Re: Proposed Building on plot No.74,
Sheet S.B.4, Saddar Bazar Quarter.

With reference to your application dated 27th September 1940
with a plan for the proposed buildings/additions and alterations on plot
No. 74 Survey Sheet No. S.B.4, Saddar Bazar Quarter,
I have to request you to comply with the following requirements—

PLAN SHOWING PROPOSED BUILDING.

ON PLOT No. 74 SHEET No. S.B. 4.

1ST. 2ND. & 3RD. FLOOR.

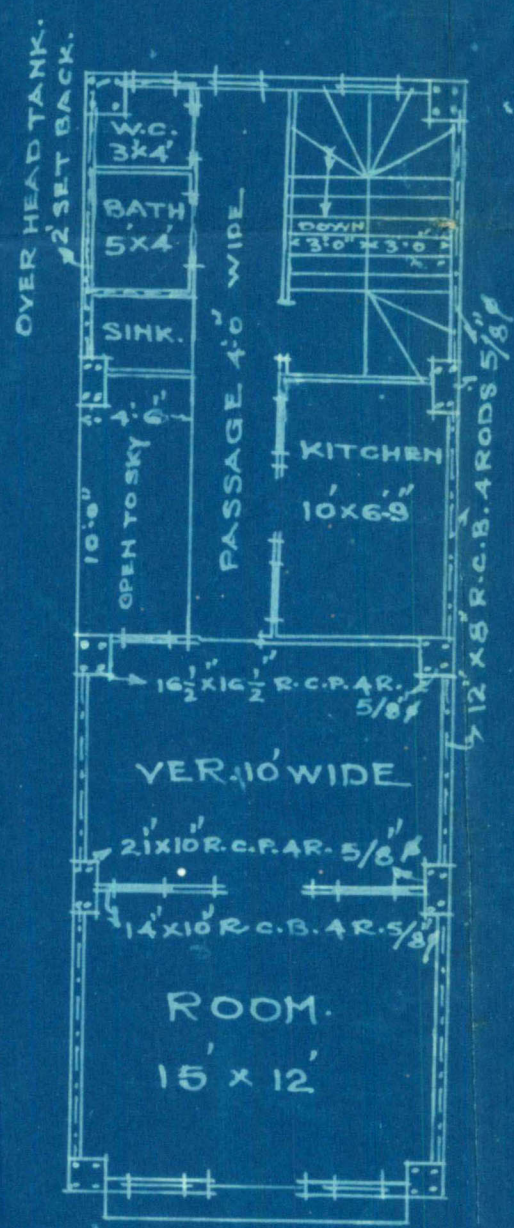
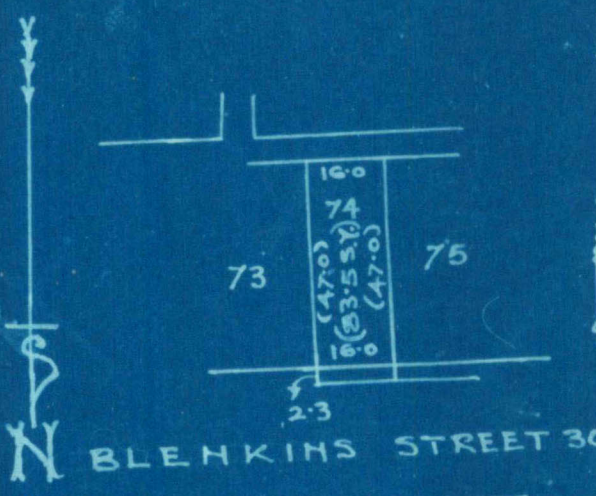
(8) Jali work instead of windows may be provided to the staircase in the rear wall, as desired, but windows are absolutely necessary and will be useful than jali work in the passages.

(9) As already shown in the plan, a cement block wall

high with Jali work over it shall be provided between the staircase and the sanitary conveniences.

- (6) Title deed be produced.
- (7) Verandahs and kitchens will be dark.
- (8) Instead of windows to the staircase and the passage in the rear wall, jalliwork be provided.
- (9) Is there a wall separating the staircase from the sanitary conveniences? If so, its height be specified.
- (10) Plinth off-sets cannot be allowed on Municipal land.
- (11) On what does the 8"x8" pillar to the N.E. of staircase-shed rest?

PLAN OF R.C.C. COVERED
STAIR CASE.

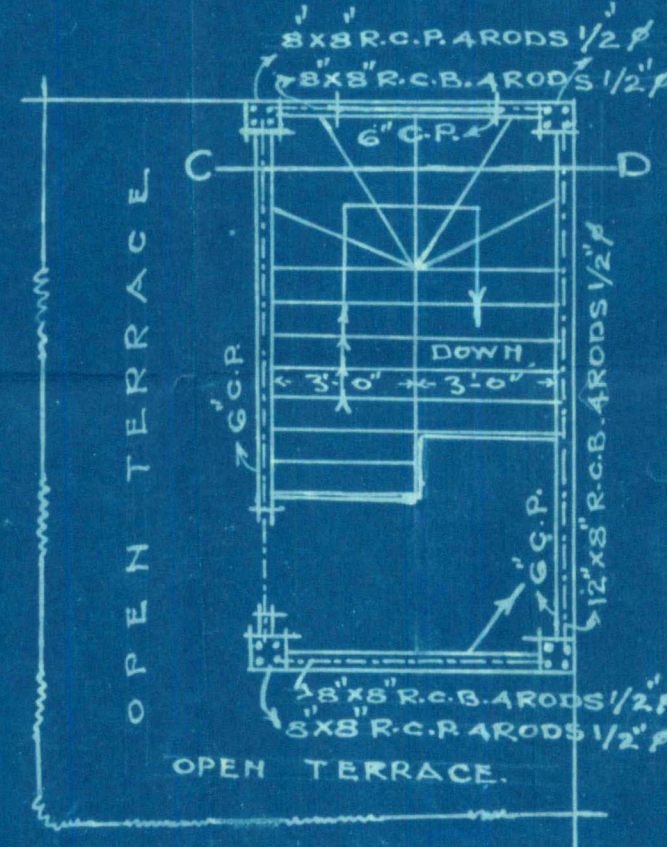
(11) As shown in the plans, the 8" x 8" pillars to the N.E. of the staircase covering shall rest on the R.C.C. beam between the Kitchen and the Staircase room.
